ADDENDUM NO. 2  
NEW FACILITIES FOR  
BENTON GAS SYSTEM  
BENTON, KENTUCKY

October 21, 2010

**OFFICE AND WAREHOUSE FACILITY FOR BENTON GAS SYSTEM**  
**BENTON CITY COUNCIL**  
**BENTON, KENTUCKY**  
**CMS NO. 342-10**  
**MARCUM NO. 10560**

**MECHANICAL AND ELECTRICAL ADDENDUM 2.00**

**XE01**

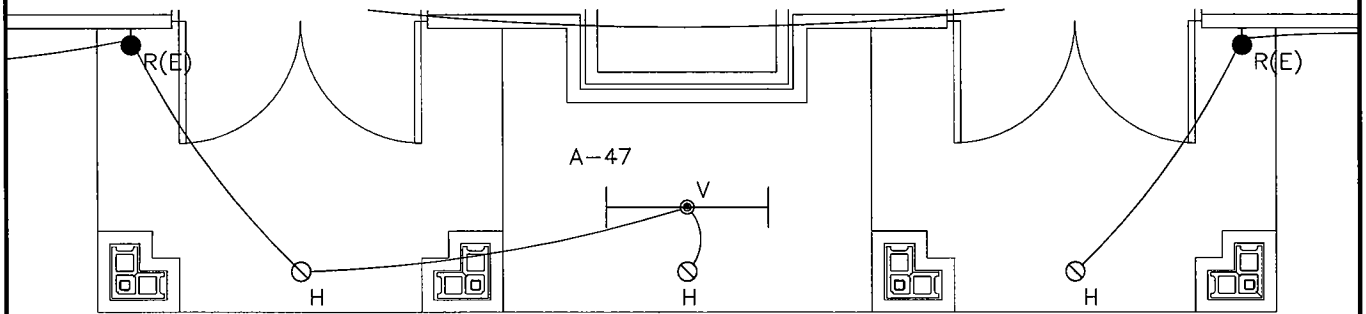
- 2.11 Reference drawing E-3. Add light fixture, conduit and wire as shown on Sketch XE01.
- 2.12 Reference drawing E-3. Relocate light fixture types R(E) and H as shown on Sketch XE02.

**XE02**

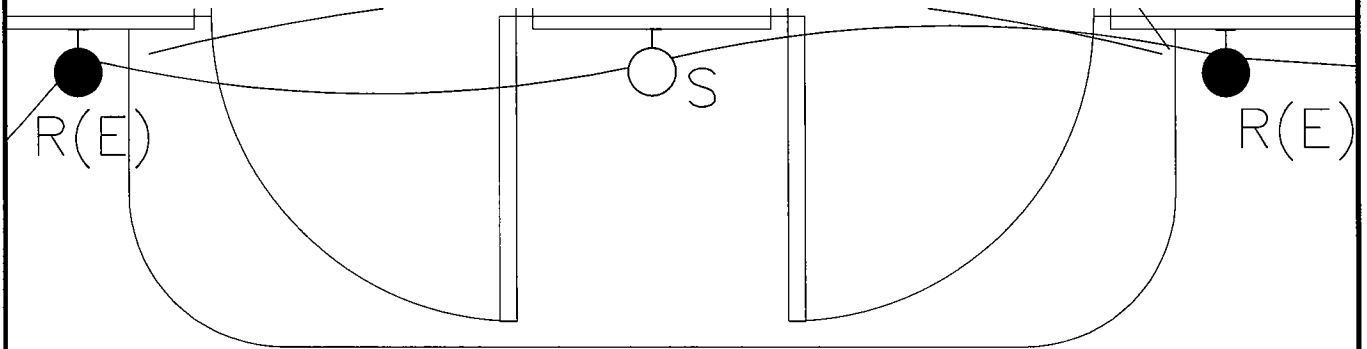
- 2.13 Reference drawing E-3. Add light fixture type V as shown on Sketch XE02. Light fixture type V shall be SPI Lighting #ECHO EEW9011 2F54 120V (or approved equal). Architect to select color.
